# ADA Curb Ramp New Construction Inspection Form (Parallel)

Nw. Glencoe rd

24952.54

Nw. Pacific st.

PARALLEL RAMP (PL)

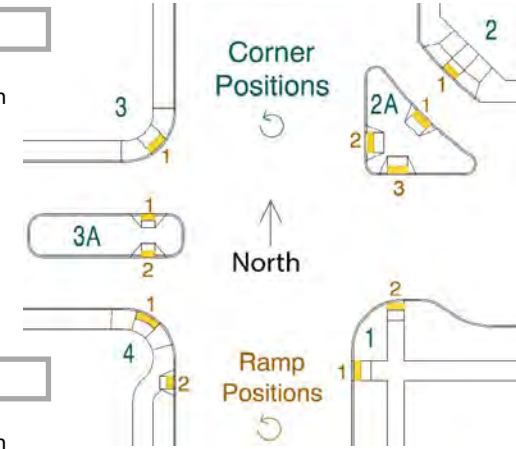
☐  $\leq 2.0\%$  ☐  $> 2.0\%$  ☒

IITD, large comm. box in RR2
